SUBMITTAL COVERSHEET **Nanuet UFSD –Phase 3 Projects**

Product Name: SHOP DWGS MIDDLE SCHOOL PIPING / COORDINATED WITH GPS SCANNING

SAGE LOG NO. M-45

12/14/2023	104° ± 1 °C	MP-01-01
------------	-------------	----------

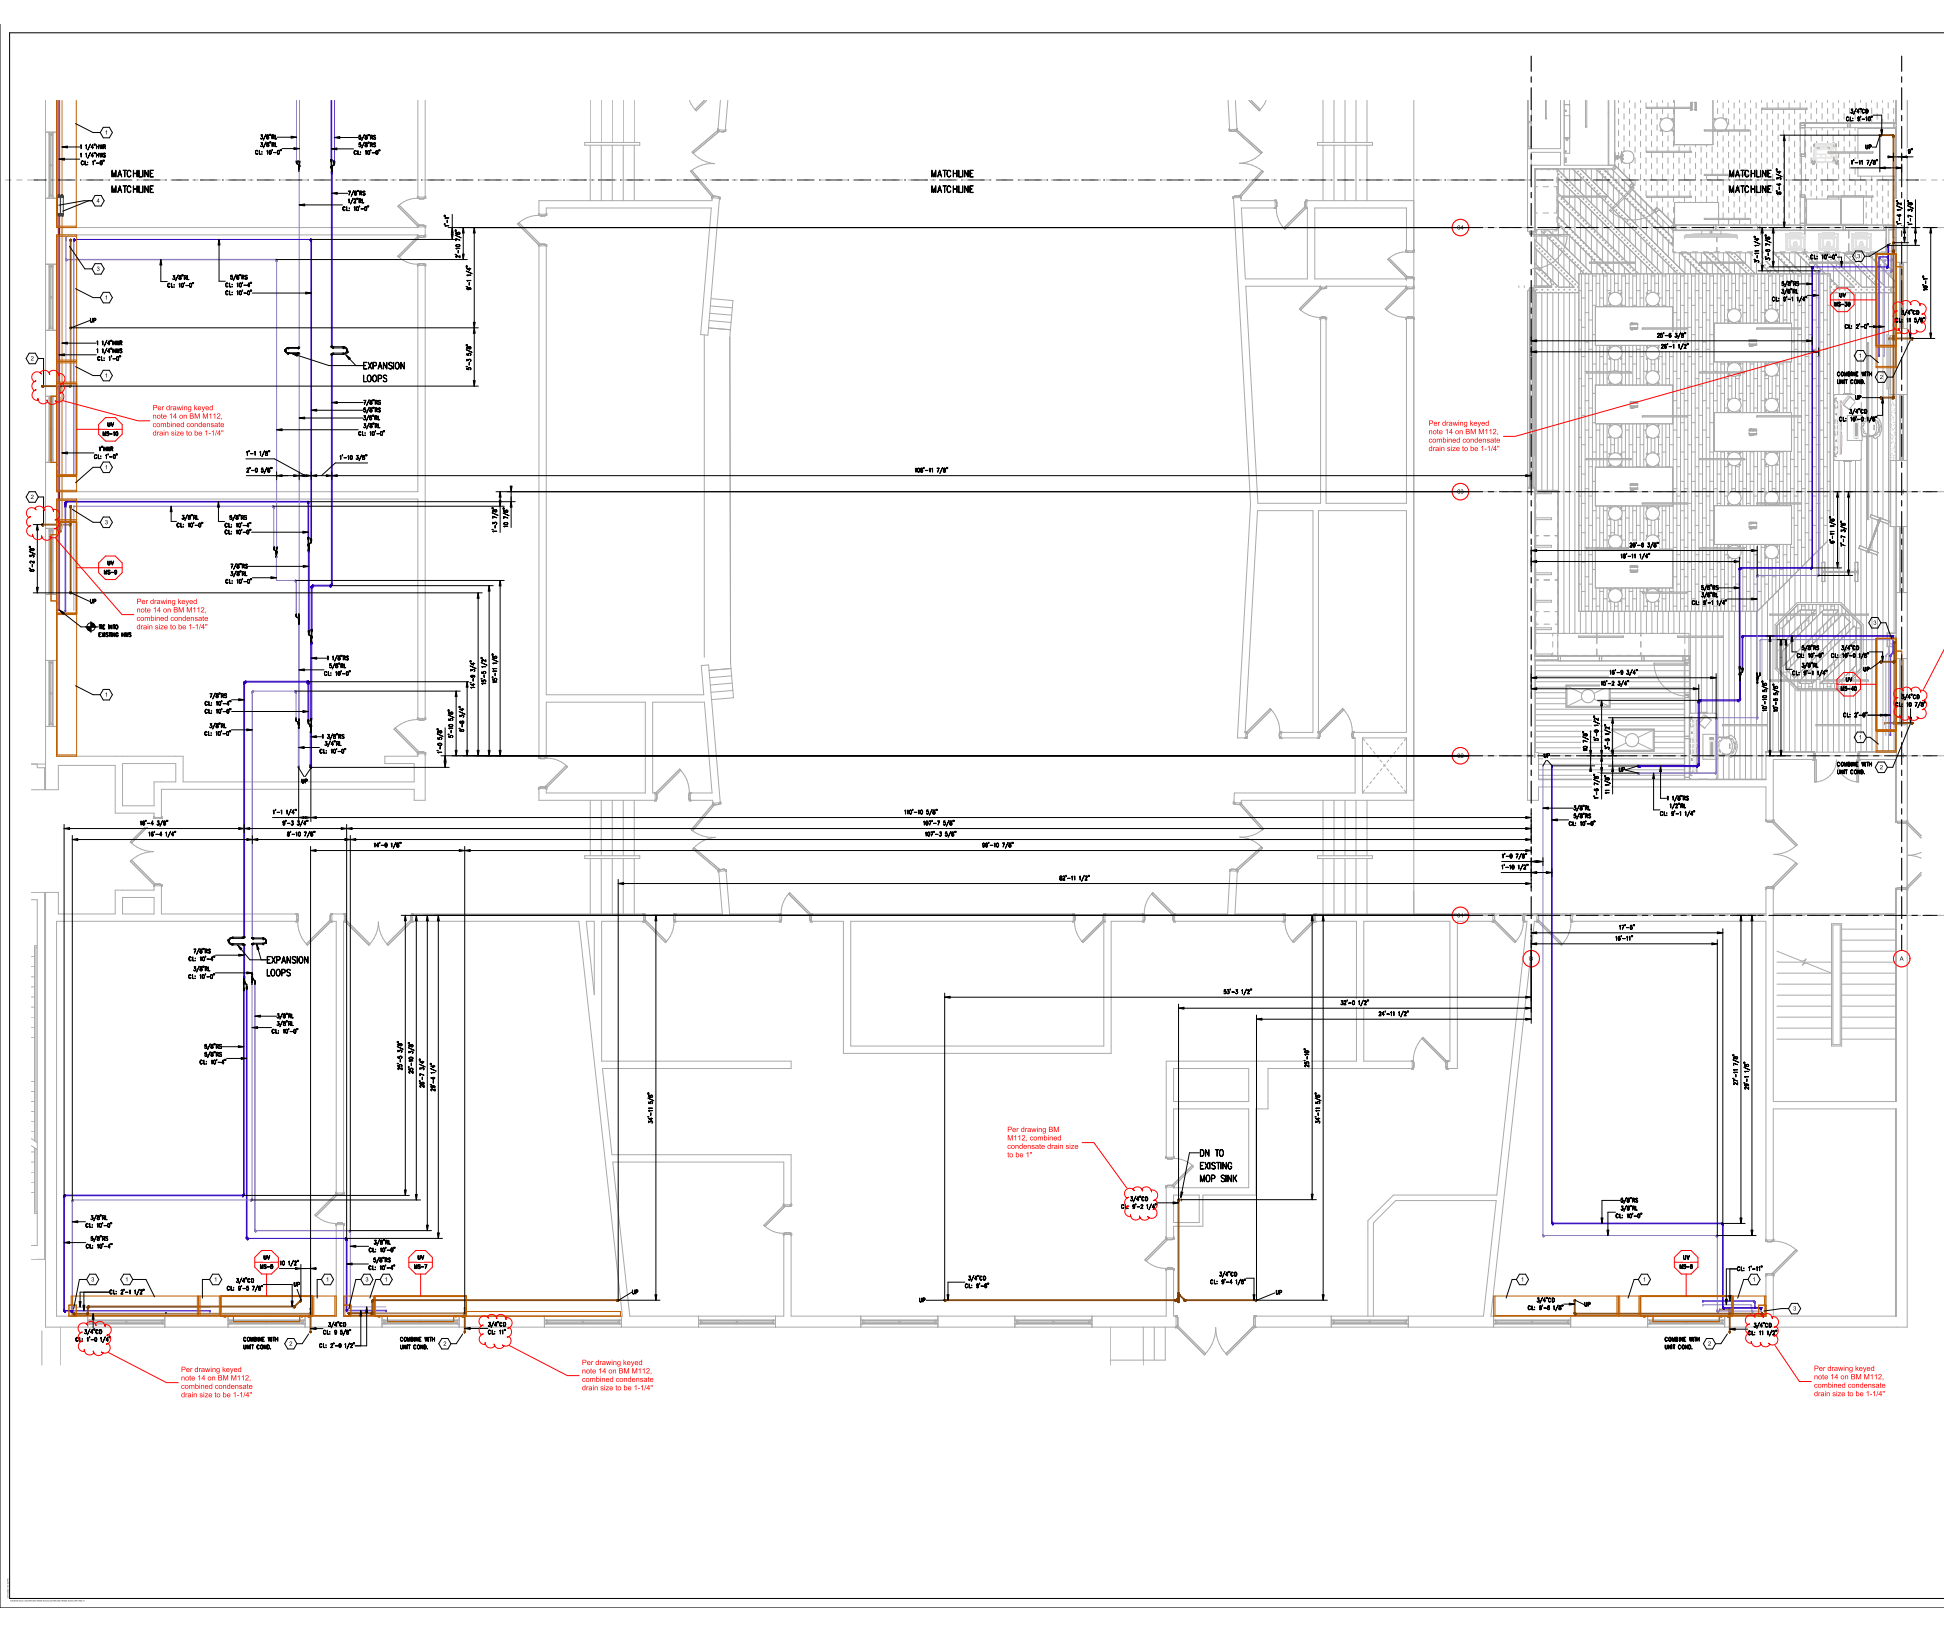
note 12 on BM M111,
combined condensate

5
Unit Ventilator Detail
Size: 1/2" x 1/2"

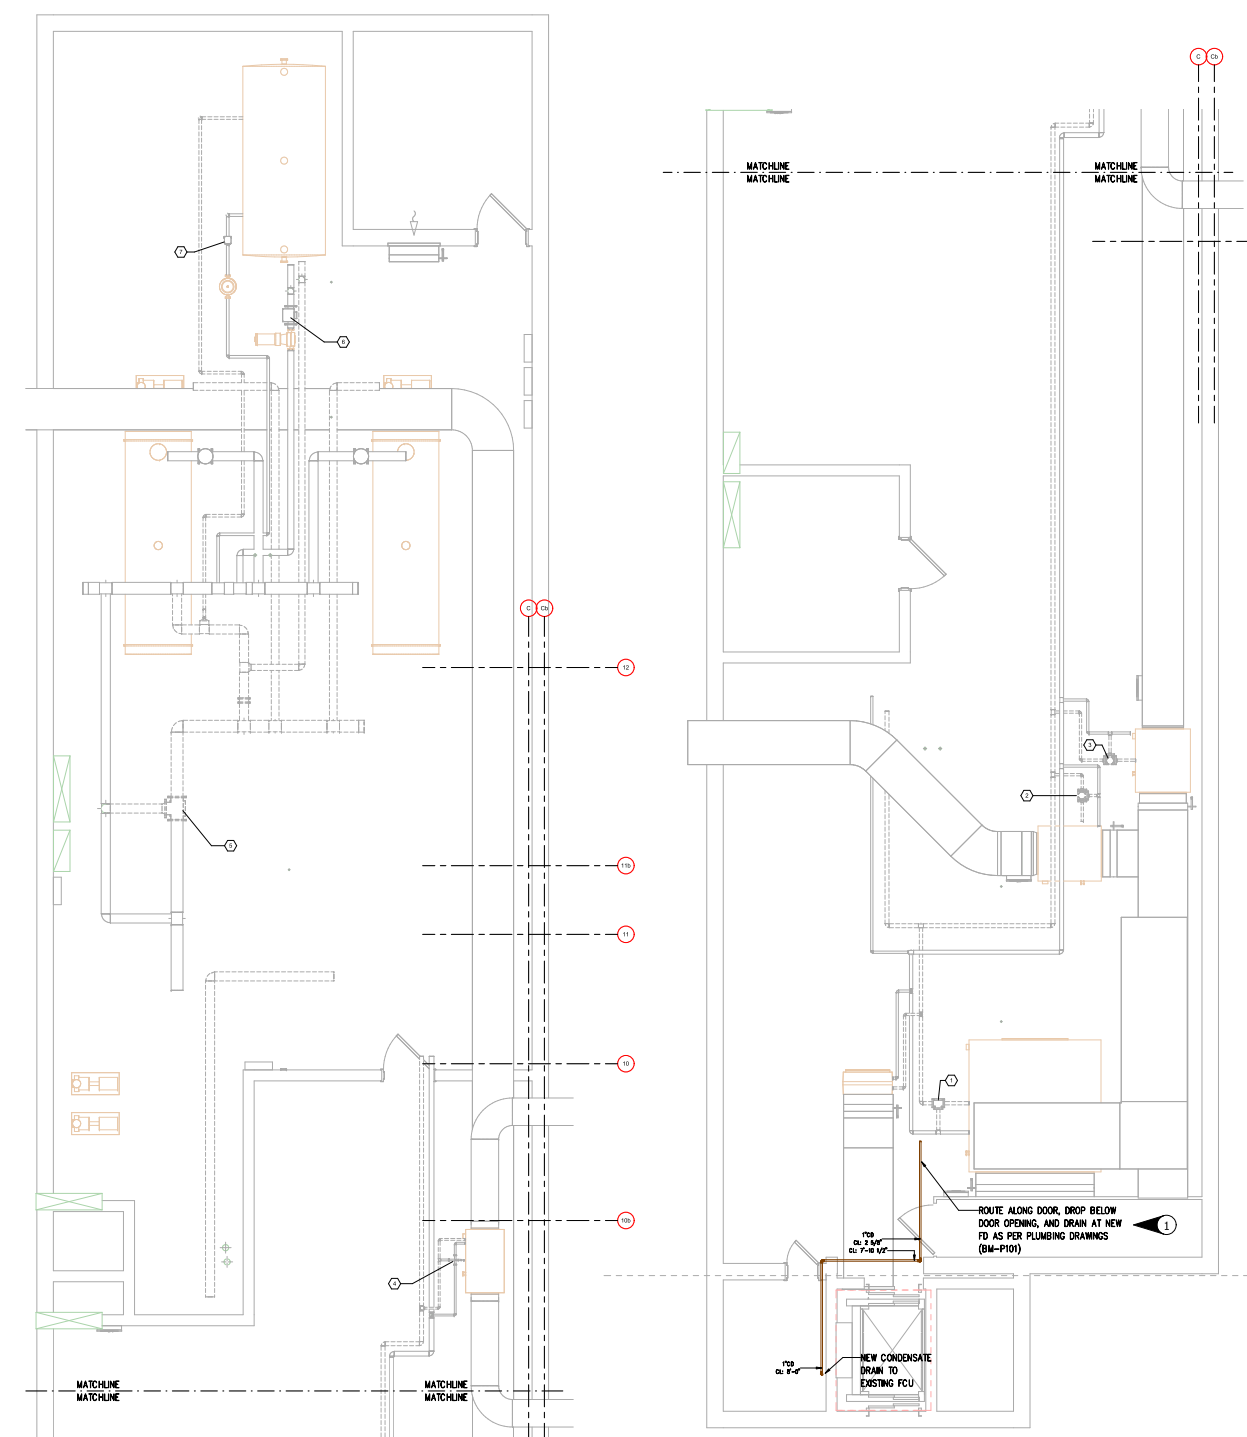
ORIGINATOR: SAGE ENGINEERING ASSOCIATES
BUILDING ELEVATIONS:
BASEMENT = -12'-0"
FIRST FLOOR = 0'-0"
SECOND FLOOR = 12'-0"
ROOF = 23'-9 1/4"
MULTI-CONNECTION PIPING KIT.
